# PARTS & SERVICE NEWS

REF NO.	AA02241
DATE	Nov. 11, 2002

**SUBJECT:** IMPROVED NEEDLE BEARING AND PLANETARY GEAR SHAFT IN 2ND CLUTCH PACK IN TRANSMISSION

4. Discrimination between the improved and current parts (Refer to the figure shown below.)

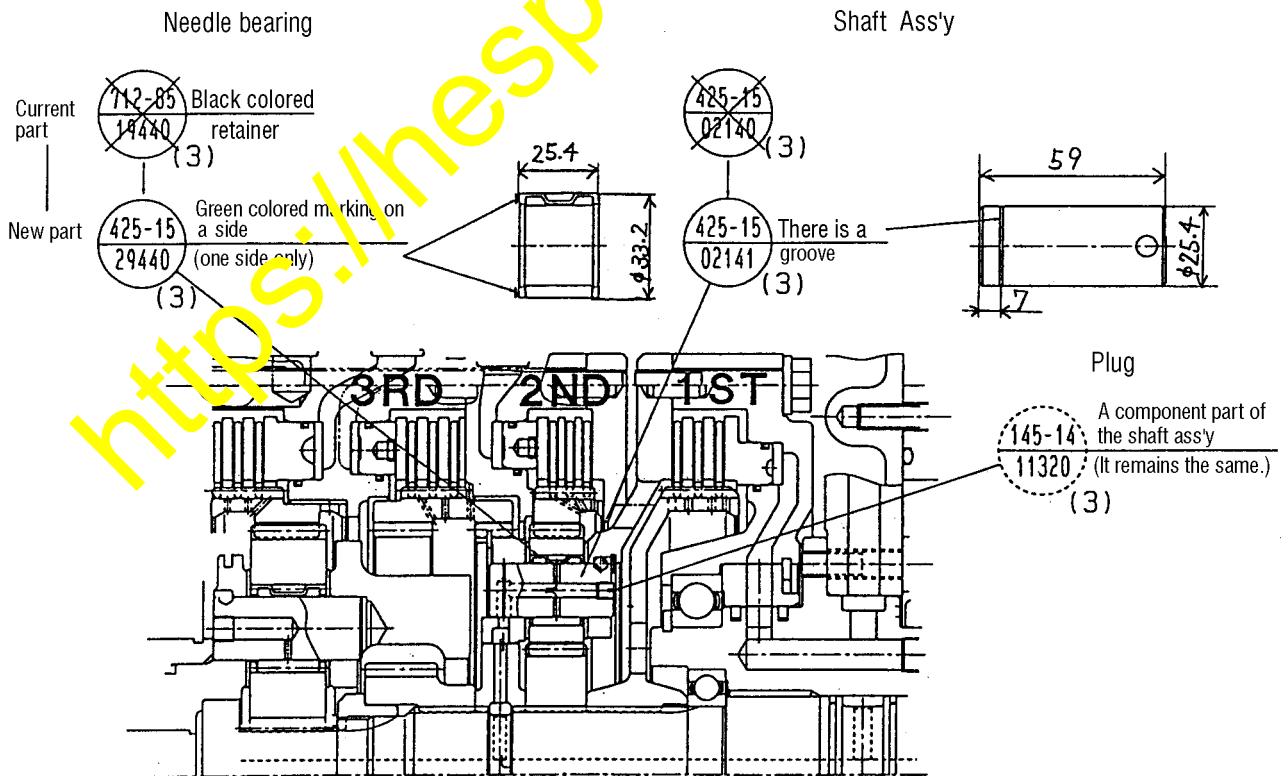
① Discrimination between the improved and current needle bearings

(Current needle bearing) Color of the retainer surface is black.

(Improved needle bearing) Color of the retainer surface is silver + a mark with green color on a side (one side only).

② Discrimination between the improved and current planetary gear shaft

(Current planetary gear shaft) There is no groove

(New planetary shaft) There is a groove (One groove only)
